AMENDMENTS TO THE DRAWINGS

REMARKS

FIG. 1
(PRIOR ART)

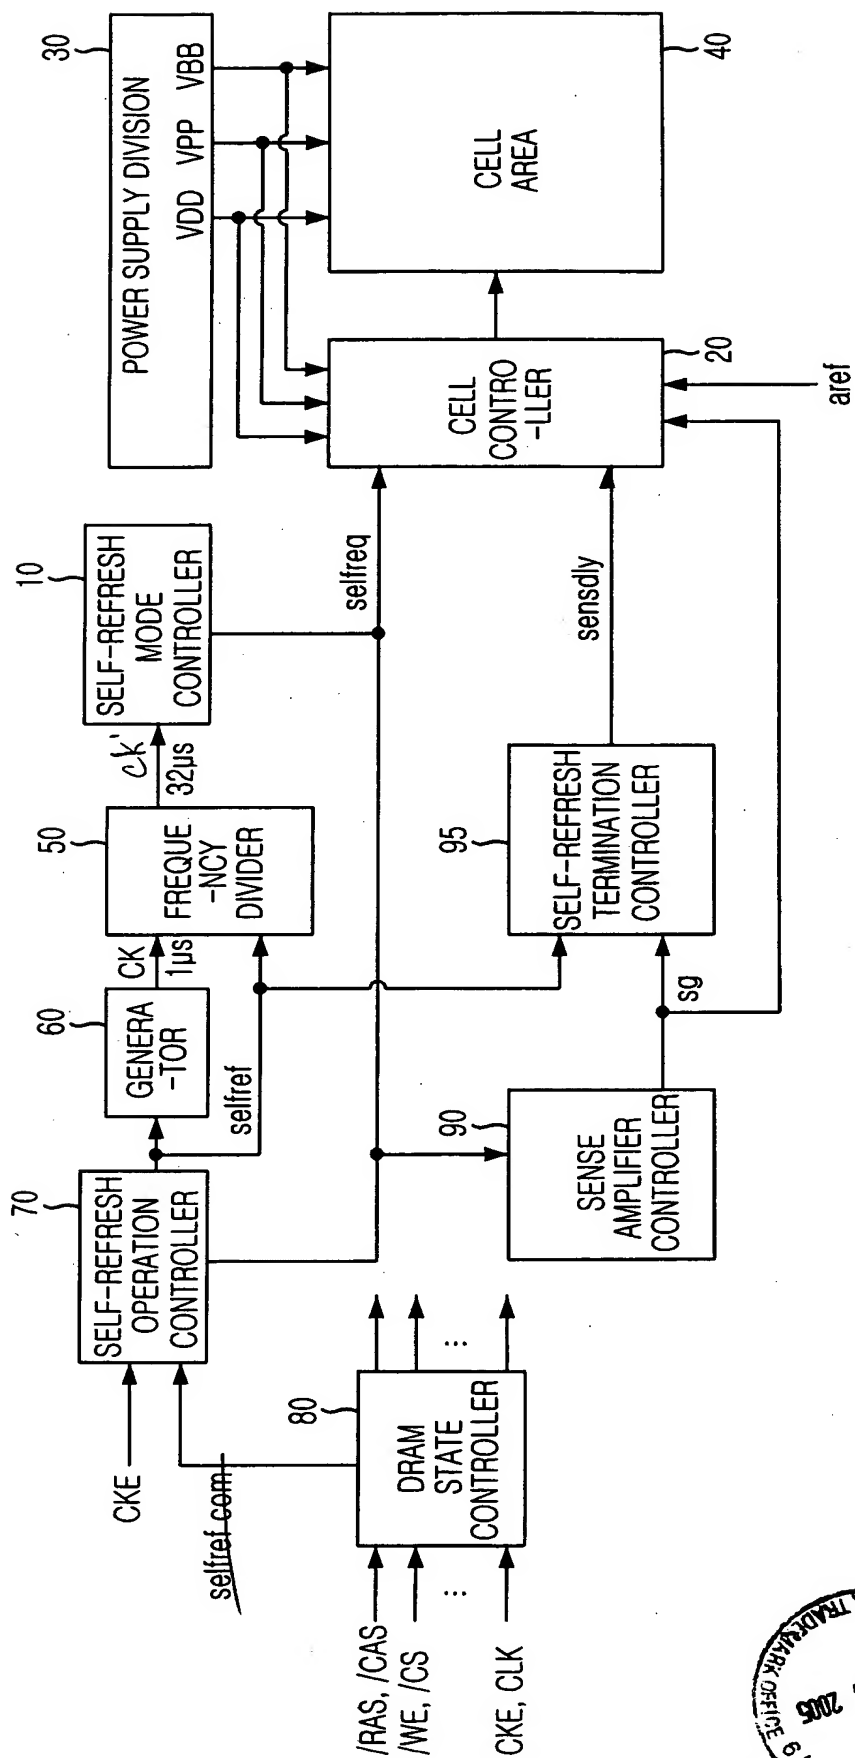
In paragraph 1 of the outstanding Office Action, the Examiner objects to the drawings under 37 CFR §1.84(p)(5) because they include the reference characters not mentioned in the description, namely, "selfref com" in Fig. 1 Prior Art; "selfref com" and "300" in Fig. 4; "D1" and "C" in Fig. 9; all elements in Fig. 11; "WL enable" in Fig. 13; "BISH1", "BISL1" and "59" in Fig. 14. Applicant respectfully submits the attached proposed amendments to Figures 1, 4, 9 and 13 in which reference character "selfref com" has been deleted from Fig. 1 Prior Art, "selfref com" has been amended to recite "selfcom" in Fig. 4, "C" has been deleted from Fig. 9 and "WL enable" has been deleted from Fig. 13. In regard to the remaining objections raised by the Examiner, Applicant respectfully submits the attached Amendments to the Specification in which characters "300", "D1", "IN11 to IN20", "BISH1", "BISL1", and "59" have been added to the specification.

In paragraph 2 of the outstanding Office Action, the Examiner objects to the drawings as failing to comply with 37 CFR 1.84(p)(5) because they do not include reference signs "ck", "selfcom"; and "ck" mentioned in the description. Applicant respectfully submits the attached proposed amendments to the drawings in which reference signs "ck" and "selfcom" have been added to Fig. 4, and "ck" has been added to Fig. 1 Prior Art.
